# **GFA AD-616**

# **GFA AIRWORTHINESS DIRECTIVE**

TWIN ASTIR & TWIN ASTIR TRAINER (not G-103).

Changes to Operating Limitations.

1.8.1 Front & rear cockpit air speed indicator: Apply a red mark at 250 km/h (135 kts. 155 mph)

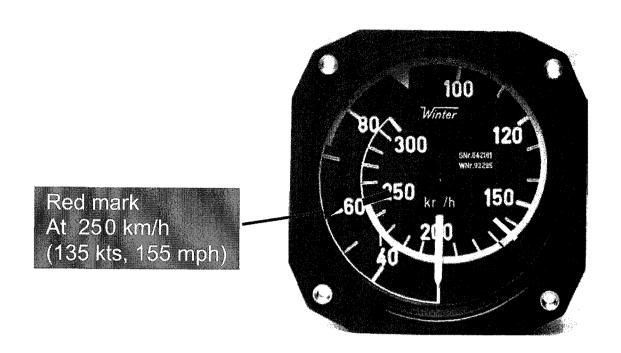
The maximum admissible speed in calm air (never exceed speed) is limited to  $V_{NE}$  = 250 km (135kts, 155mph), the same limits apply to  $V_{DF}$  (Speed with airbrakes extended). The maximum speed in rough air is limited to  $V_{B}$  = 170 km/h (92 kts,105 mph). Complete the following actions.
